Plant: Harris Nuclear Plant Submittal Date: 10/26/06
Submitter Contact: Jeff Ertman Phone: 919.546.2662
Submitter Email: jeffrey.ertman@pgnmail.com

NEI 04-02, Section 5.3 and Appendix I.

Recommend making nuclear safety and radioactive release questions first in screening reviews in order to determine necessity for Chapter 3 features and systems.

Figure 5-1 - Plant Change Evaluation

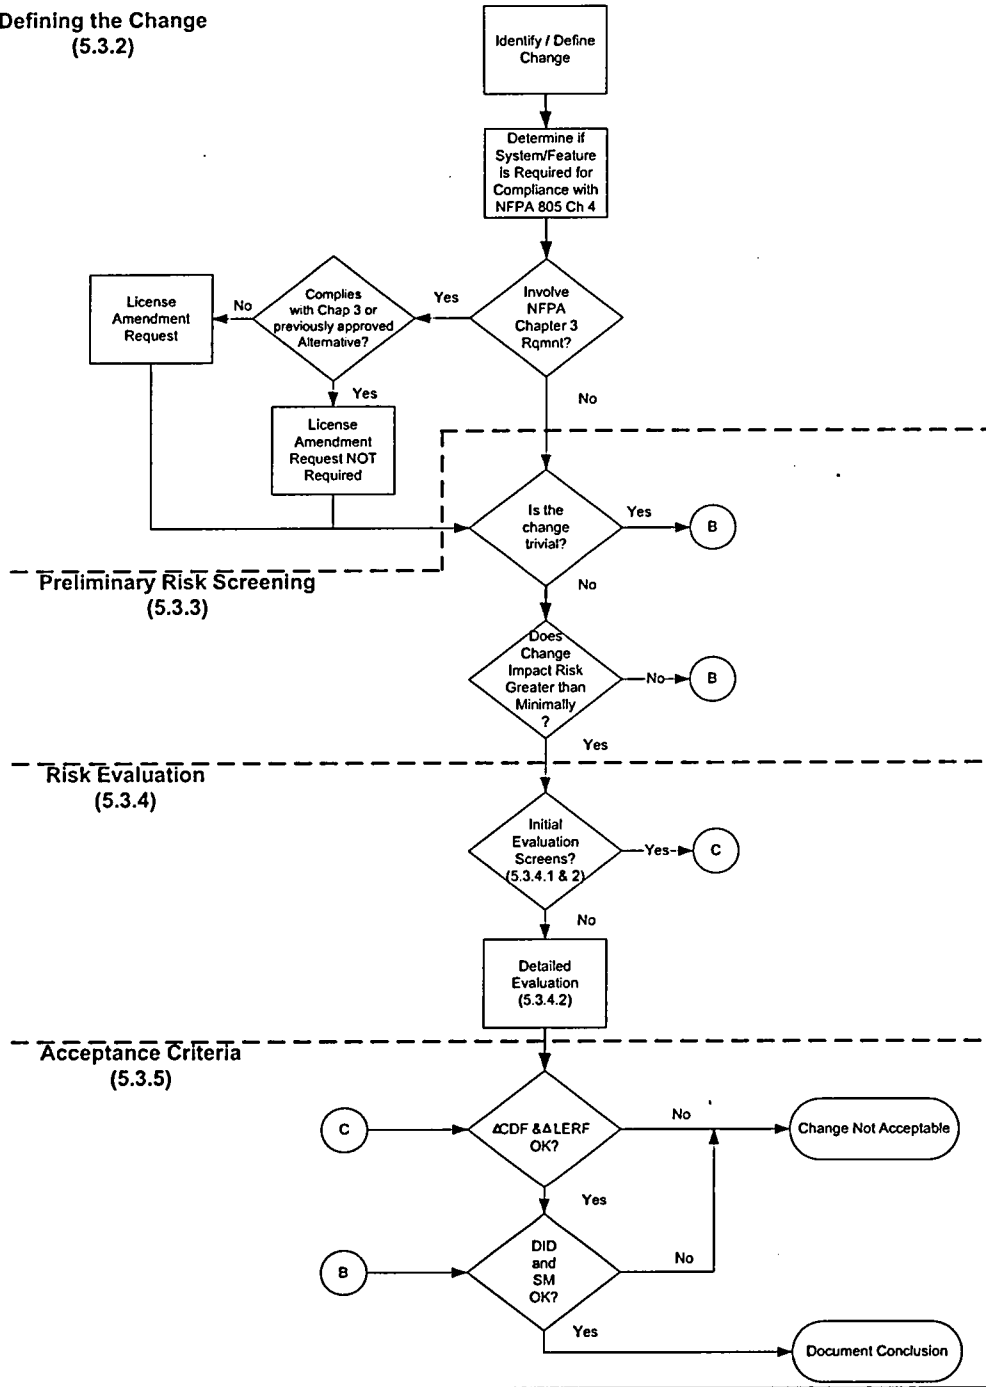
Additional consideration should be given to changes to Fundamental Program Elements and Minimum Design Requirements. Since many of the fire protection systems/features in NFPA 805 Chapter 3 are the result of meeting the Chapter 4 performance criteria, the change review process should determine the Chapter 4 requirements first in the change identification process.

Revise NEI 04-02 Section 5.3 and Appendix I, to reflect the revised order of questions.
